SAN ANTONIO WATER SYSTEM

**SAWS Desalination Production Well
Construction Services – Package I
Wells BGD 5-8
Job No. : 10-8610
Solicitation No.: B-11-036-DD**

**Addendum No.: 1
February 7, 2012**

DRAWING NO.
C-7.0
07 OF 09

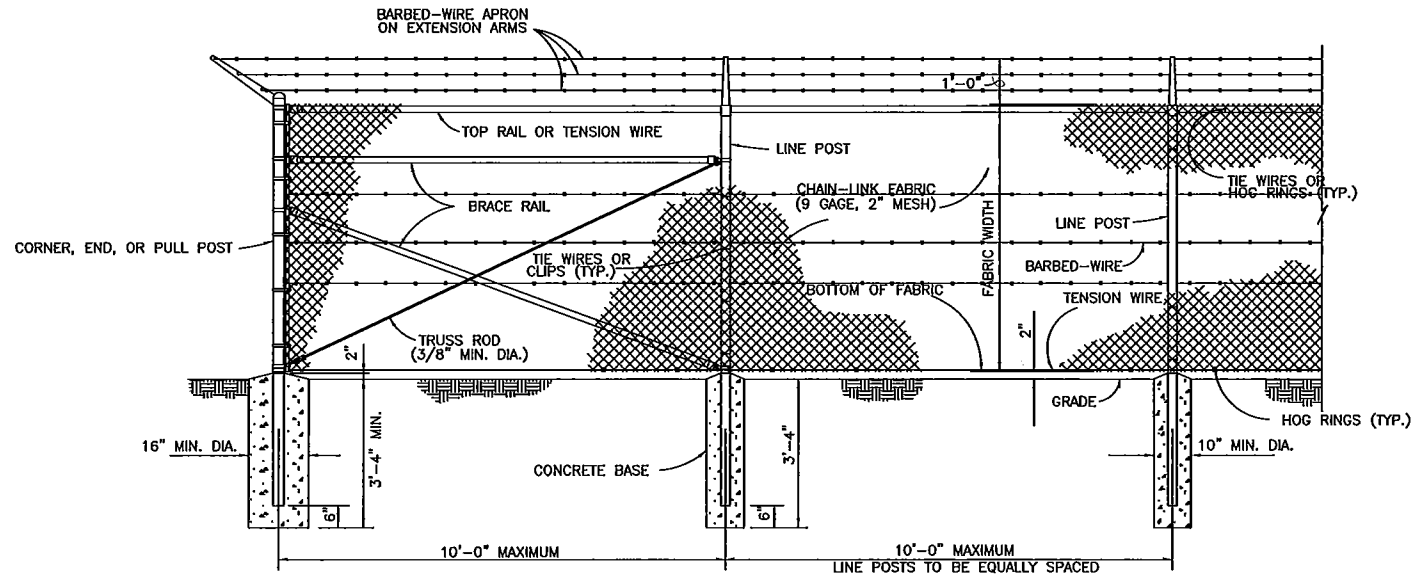
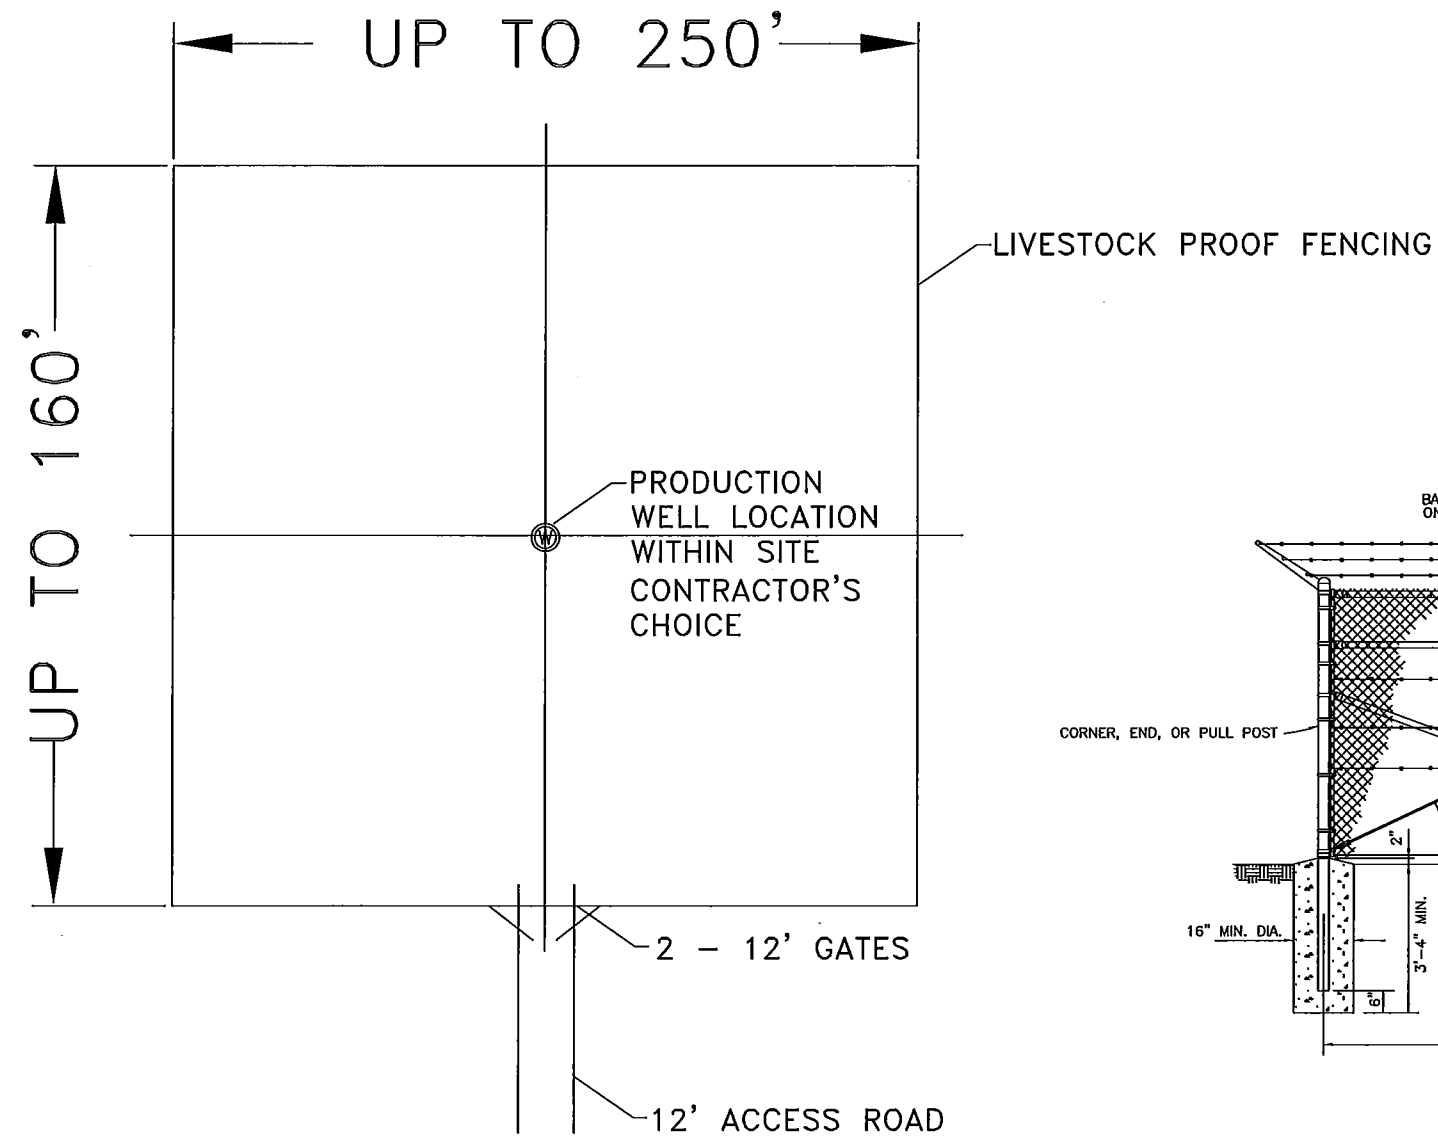
1. Drawing C-2.0: Delete the label “Hardy Road” on the north-south road and replace with “Mathis Road”.
4. Drawing C-4.0: Delete the label “Hardy Road Bore” and replace with “Mathis Road Bore”.
5. Replace Drawing C-7.0 in its entirety.
6. Replace Drawing C-8.0 in its entirety.
